**FINAL DESIGN REVIEW RECOMMENDATIONS  
OF THE  
NORTHEAST DESIGN REVIEW BOARD**

**October 18, 2010**

**Project Number:** 3009828

**Address:** 1214 North 43<sup>rd</sup> Street

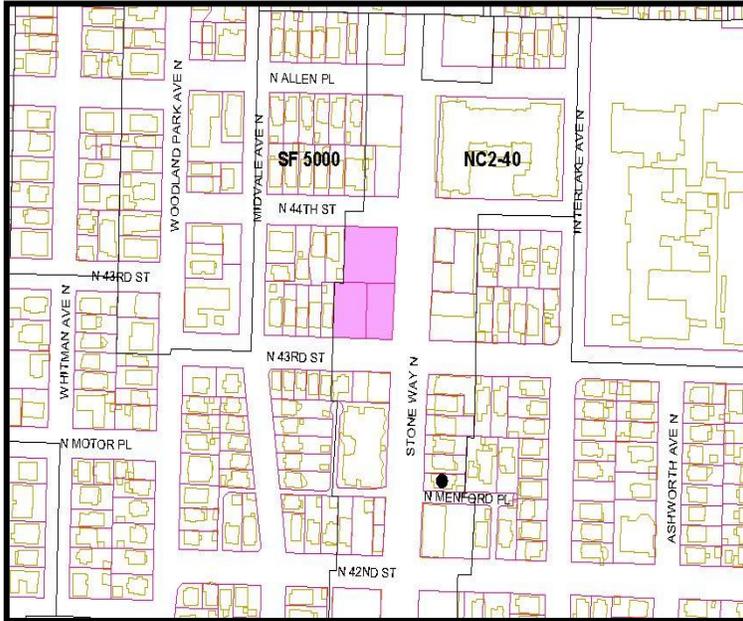
By the Recommendation meeting, Scheme #3 evolved to form a tripartite mass along Stone Way N with the corners anchored by commercial spaces at grade and entries at chamfered corners that extend the full of the height of the proposed structure. A middle section, with its irregular mass slightly set back from the street, forms a narrow but linear plaza along Stone Way. Within this plaza, a residential entry and lobby sequence and another commercial storefront form the ground floor. Brick masonry units delineate the ground floor commercial spaces. Above the first level, the middle section of the scheme is composed of a series of projecting bays and residential balconies set in from the primary plane of the wall. The two corner masses are differentiated from the mid-section of the composition by the lack of bays and balconies creating quieter facades in contrast to the visual staccato of the middle section. Color choices for the fiber cement panels also set the corner masses apart from building's middle realm.

The length of the Stone Way façade combined with a similarity of materials and colors produces a visually monotonous elevation. The Board recommended that the applicant further differentiate the center segment of the tripartite scheme from the corner masses. Possibilities suggested by the Board include raising the height of the brick and changing the brick's color in this section of the building. One aspect of this larger revision should concentrate on the appearance of the primary residential entry. The columns near the right-of-way and the deeper canopy were not enough to differentiate the entrance from the commercial entries or signify its importance on the overall façade.

The Board found the use of the white fiber cement panel at the two corner entries prosaic. If the corners are to be celebrated by the chamfers for the structure's full height then the corners should have a better quality material in keeping with its importance.

The Board found the primary residential entry on Stone Way lacking in both prominence and imagination in spite of the free standing columns and the extended canopy. The Board emphatically recommended that the architect re-conceptualize the entry's presence on the façade. It should read as a significant element of the middle section of the tripartite façade.

- 1) Further differentiate the center segment of the tripartite scheme along Stone Way N. from the corner masses. Possibilities suggested by the Board include raising the height of the brick and changing the brick's color in this section of the building. (C-2)

- 2) Revise the appearance of the primary residential entry to differentiate the entrance from the commercial entries and to signify its importance on the overall façade. The primary entrance should be part of a larger revision of the middle section of the Stone Way façade. The entrance should read as a significant element of the middle section of the tripartite façade. (C-2, D-12)

- 4) Use a better quality material than white fiber cement panel in keeping with the importance of the chamfered corners. (C-4)
- 5) Use street lighting fixtures recommended by the Wallingford neighborhood council for the Stone Way N. corridor. (D-7)
